# *Liverpool Growth Centre Precincts*

*Amending Development Control Plan  
(Austral ILP Amendment)*

*(Pre-Gateway) May 2019*

Note this draft DCP omits text which are not intended to be amended. Several sections objectives and controls have not been reproduced in this document, only sections of relevance have been displayed. Text which is to be inserted is shown in green and underlined, text which is to be deleted is shown in ~~red with strikethrough~~, explanatory notes, which will not form part of the DCP, are shown in *blue italics*.

**Figure 3-1:** Dwellings are to be oriented to face public open spaces

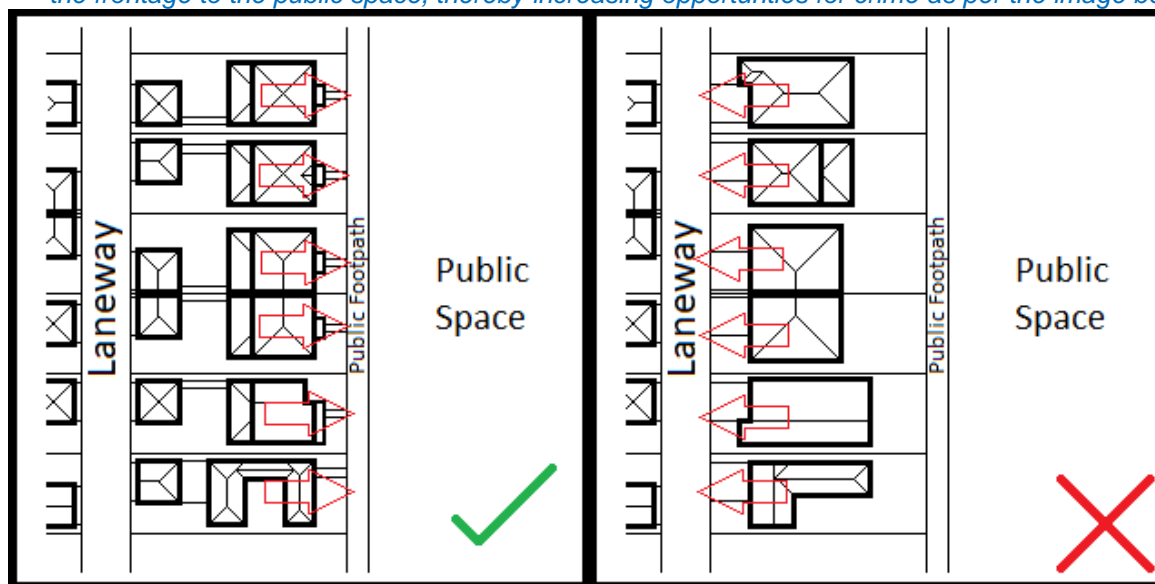
11. Where residential development adjoins land zoned RE1 Public Recreation or SP2 Drainage, subdivision is to create lots for the dwelling and main residential entry to front the ~~open-space-or drainage-land~~ public space. *As per below there are other circumstances where dwellings should overlook public spaces to provide a sense of passive surveillance, reducing opportunities for crime.*

12. In instances where an ILP identifies a public footpath adjacent to one lot boundary and a public laneway as adjacent to an opposite boundary, the dwelling and lot configuration is to orient dwellings to face the public path, with vehicular access being provided via the laneway. A s.88b instrument shall reinforce dwellings to be oriented to the public path/easement. See Figure 3-4 below. *As per the proposed ILP, there are a few instances where there is a desire for dwellings to face areas of open space, such as parks, drainage lands or easements, providing passive surveillance. In these instances the road frontage, being a laneway, are desired to be the back of the lot. A s.88b instrument is a legal document attached to land parcels, which specifies matters such as easements and special conditions. Given that these lots will have an unusual back-to-front arrangement, and given that dwellings can be constructed as complying development, not assessed by Council, it is important that a lot restriction be placed on these lots to ensure that dwellings will face the public space, providing for surveillance. Without the S.88b control dwellings may face the laneway (undesirable) and a back fence could screen the frontage to the public space, thereby increasing opportunities for crime as per the image below*

**Figure 3-134:** Typical local street *New Section is as per description in Council Report dated 27 March 2019*

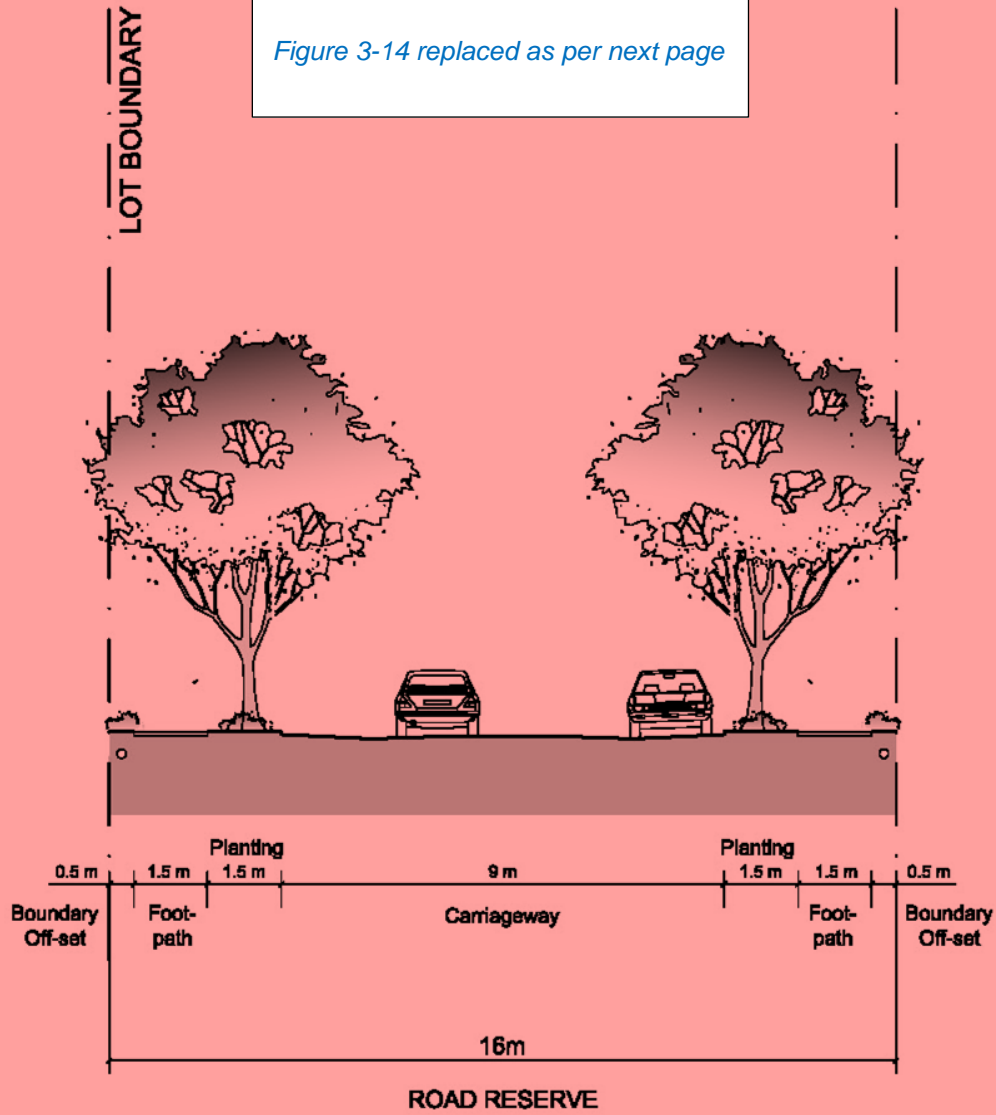
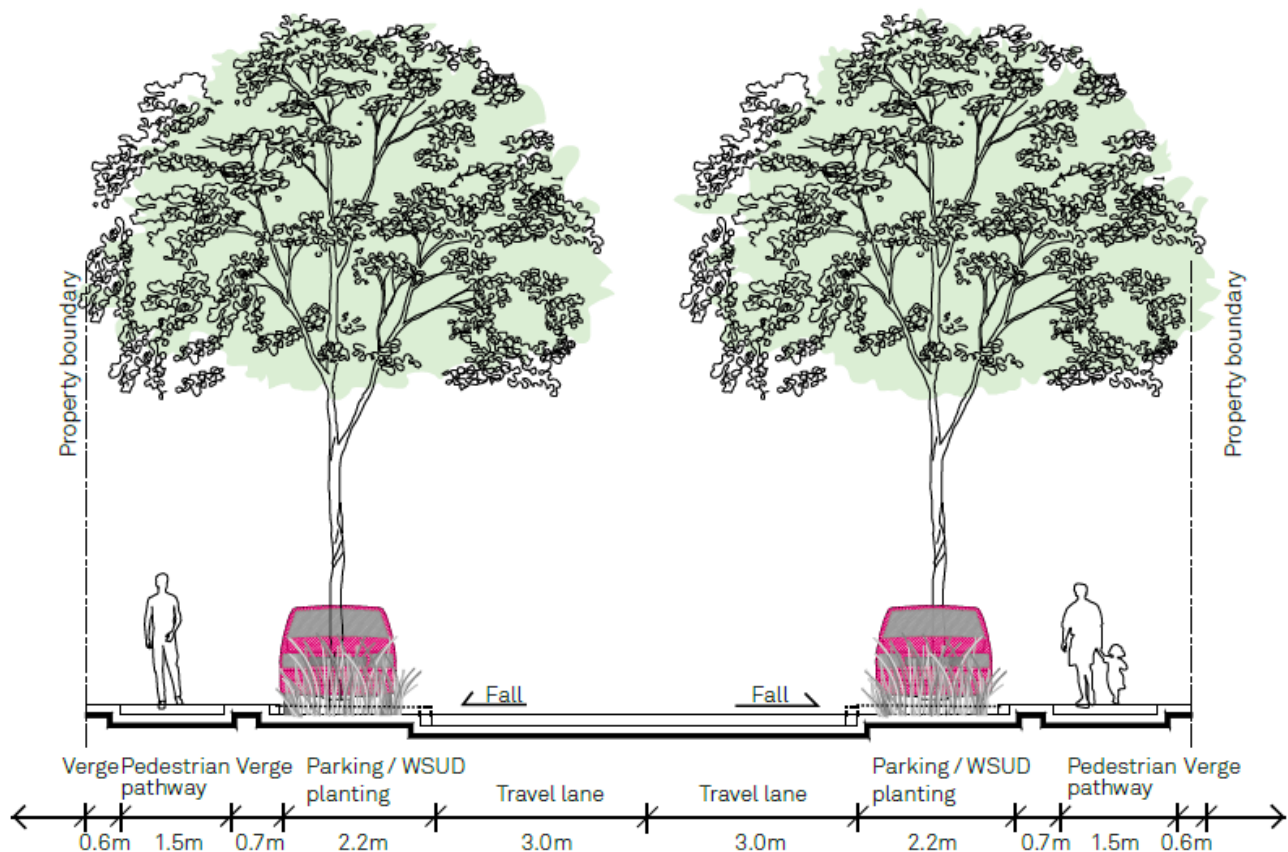
Figure 3-14 replaced as per next page

Figure 3-25: Typical Local street (existing 20m reserve)

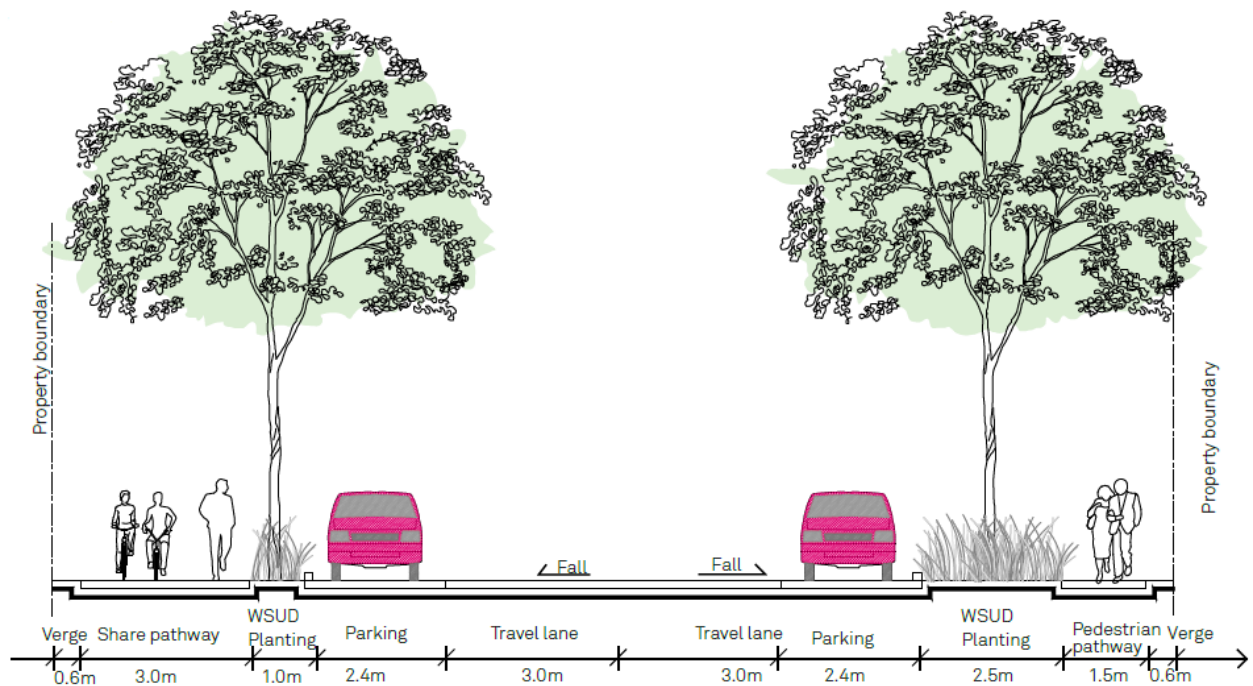
15. Local streets which are located within an existing road reserve are to be designed and constructed in accordance with Figure 3-15. *There was no cross section as to how local roads (16m) were to be re-constructed in several of the existing road reserves (20m). This new figure will clarify Council's position*

Figure 3-15: Preferred street tree and parking arrangement for subdivisions with narrow front-loaded lots

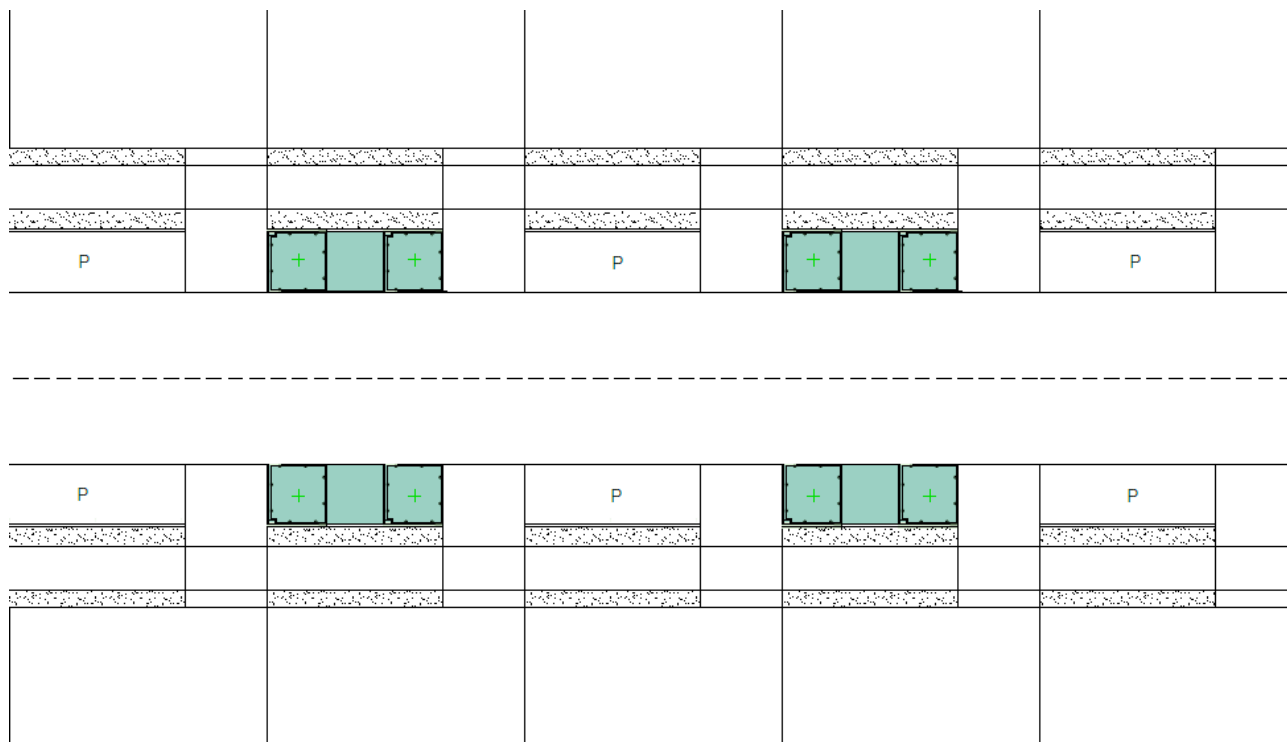
- On 16m local streets where front-loaded lots are  $\leq 9\text{m}$  wide the location of driveway crossings are to align with any zero-lot lines, are to be shown on the subdivision plan. The plan must demonstrate that one street tree is planted per lot with the spacing of street trees generally every 4-18m; space between tree bays and driveways are to facilitate on-street parking. A preferred arrangement is shown in Figure 3-.

Due to some roads having street trees planted in the verge and some having them planted in the carriageway, there was a need to amend this control to provide guidance for each situation. The approach for street trees planted in the road reserve has to be thought out very carefully at the subdivision stage to make sure there is adequate space for parking as well as avoiding the need to remove/relocate trees to avoid interfering with driveways or underground utilities. The width of lots will also impact on the location of tree planting/ parking bays as very narrow (<9m wide) lots can only accommodate a parking spot or street trees (not both), whereas wider blocks (>13m wide) the street may be able to incorporate a mix of single and double parking bays including street trees. The text has also been updated to refer to Torrens title lot, rather than dwelling, due to potential issues with strata developments and uncertainty on the number of trees required.

**Figure 3-44 3-17:** Typical access street *The new section is consistent with other, in that the parking bay will be visually distinct from the travel lanes, providing greater clarity and avoiding driver confusion.*

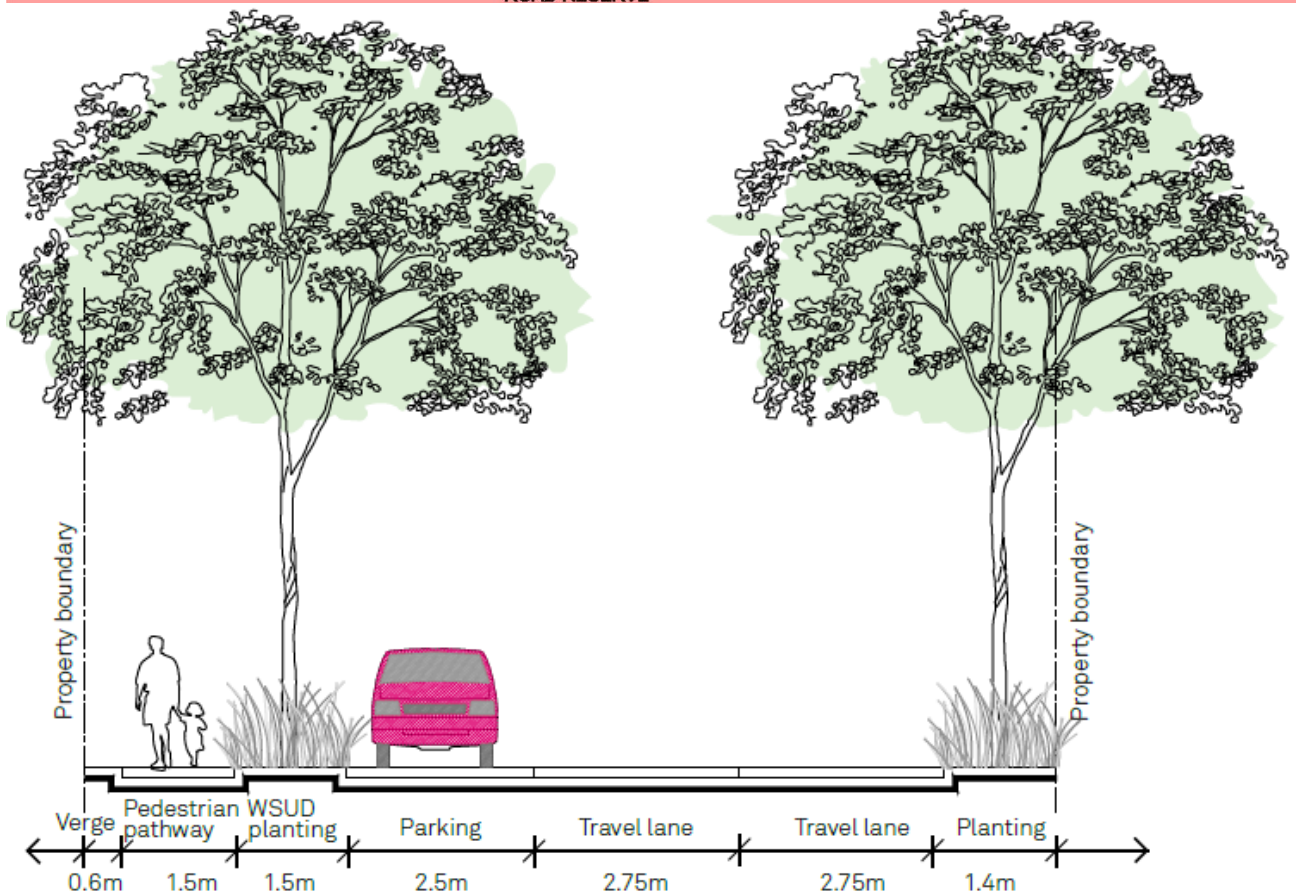
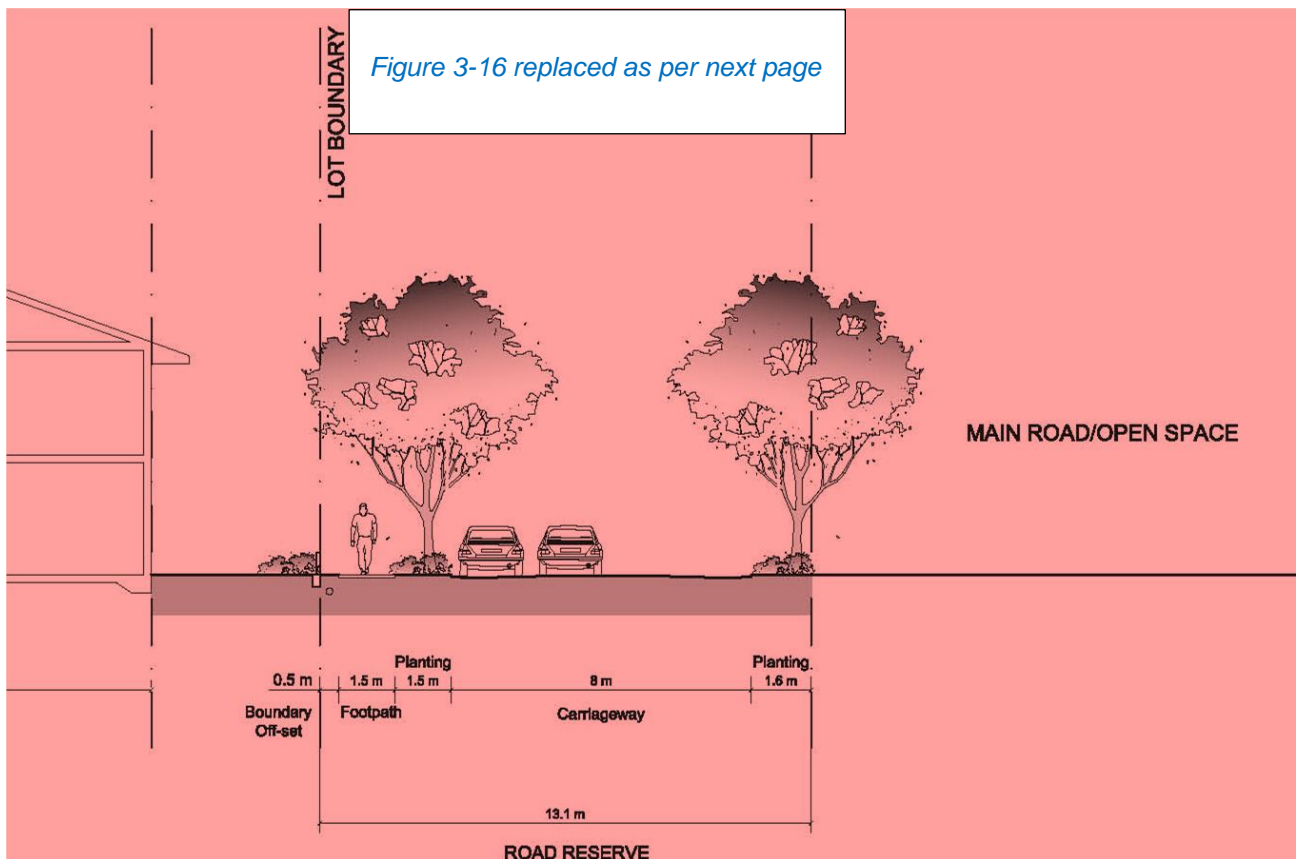
22. – 28. Controls 23-29 renumbered to 22-28.
- ~~30. The carriageway width of an access street may be reduced to a minimum of 6.5 metres subject to consideration of traffic volumes and road safety issues. This is inconsistent with the new cross sections. Parking bays will be required on one side to ensure vehicles can pass one another when passing a parked vehicle.~~

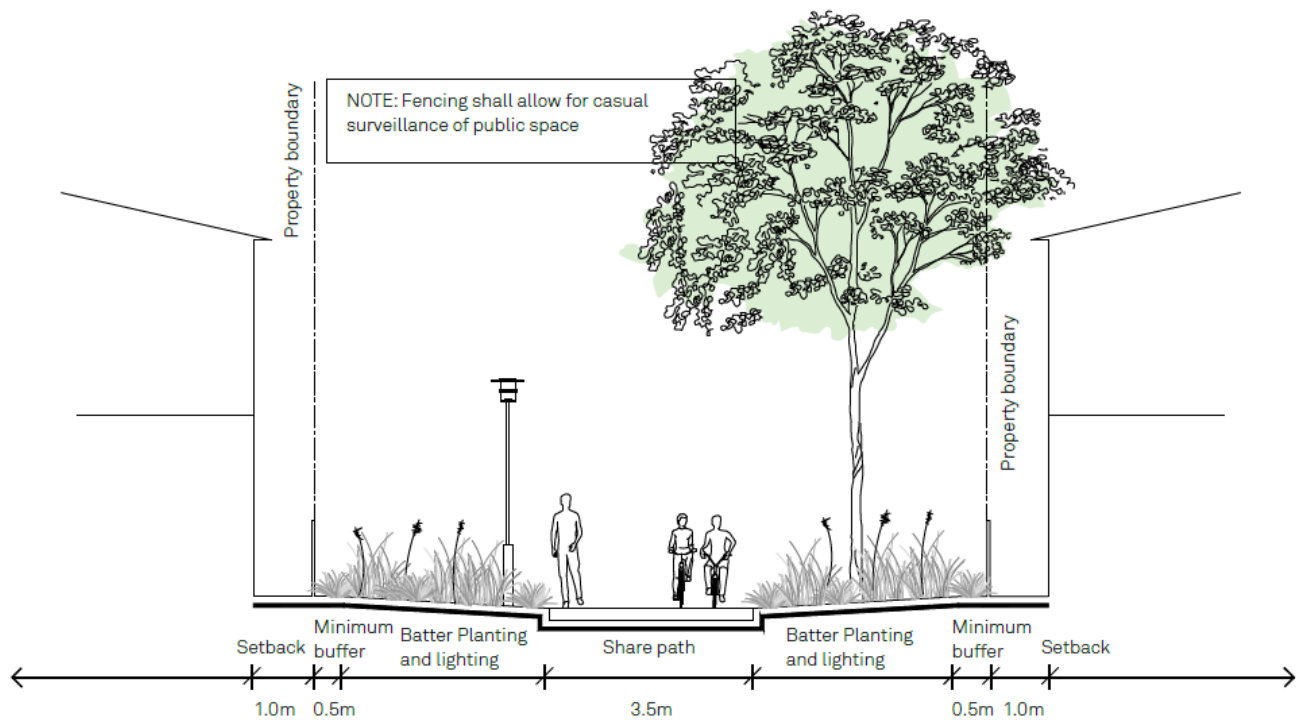
**Figure 3-24: 10.0m Typical Pedestrian Access Path** *The amended ILP introduces a limited number of pedestrian only paths. Assessment of stormwater drainage for each DA also necessitates overland flow paths in some instances to resolve localised flooding issues. This standard cross section should allow for overland flow, and is sufficiently wide so as to prevent opportunities for concealment and other crime related activities.*
